Access Compliance Report

Public Rights-of-Way

(Curb Ramps)

Intersection ID: 29985	Main Street: NELAND_LN	Cross Street: WINDING_RIVER_DR	Location: S
ADA ID: 60E73649CF77	Ramp Type: Perp	Initial Pass/Fail: Fail	Overall Compliance: No
Severity Score: 33.75			
Codes/Mitigation Info/Possible Solution		Field Measurements/Component Compliance

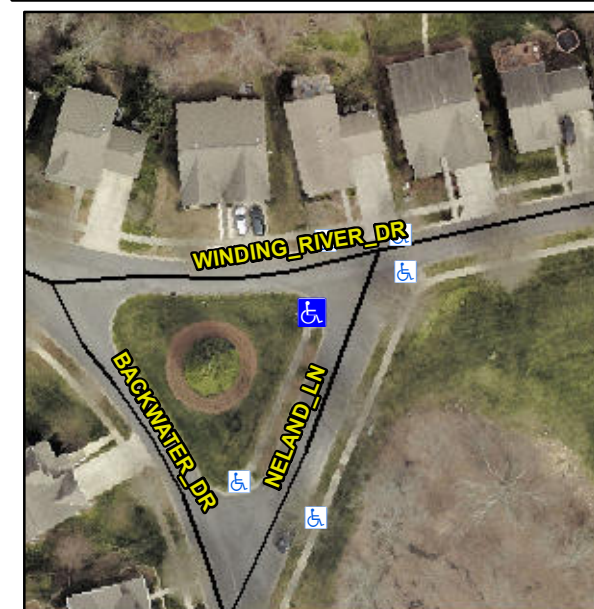
Not Found, R304.5.1, R304.5.3

Compliance	Description	Data	Compliance	Description	Data
N/A	Ramp Length (in)	72.0	Yes	Ramp Slope (%)	5.0
No	Ramp Width (in)	47.5	No	Ramp XSlope (%)	14.0
N/A	Flare Type LT	N/A	N/A	Flare Type RT	N/A
N/A	Flare Slope LT (%)	N/A	N/A	Flare Slope RT (%)	N/A
N/A	Flare Traversable LT?	N/A	N/A	Flare Traversable RT?	N/A
N/A	Landing Length (in)	N/A	N/A	DWS Provided?	N/A
N/A	Landing Width (in)	N/A	N/A	DWS Contrast?	N/A
N/A	Landing Slope (%)	N/A	N/A	DWS Length (in)	N/A
N/A	Landing X Slope (%)	N/A	N/A	DWS Full Width?	N/A
N/A	Landing Curb? (Y/N)	N/A	N/A	DWS Offset (in)	N/A
N/A	Shared Landing?	N/A			
N/A	Gutter Ponding?	N/A	N/A	Gutter Slope (%)	N/A
N/A	Gutter Lip Ht (in)	N/A	N/A	Gutter X Slope (%)	N/A
N/A	Painted X Walk1?	No	N/A	Painted X Walk2?	N/A
	X Walk 1 Direction	To NE		X Walk 2 Direction	N/A
N/A	X Walk 1 Width (in)	N/A	N/A	X Walk 2 Width (in)	N/A
	X Walk 1 Slope (%)	1.4		X Walk 2 Slope (%)	N/A
	X Walk 1 X Slope (%)	8.1		X Walk 2 X Slope (%)	N/A

Remove & Replace Entire Ramp.
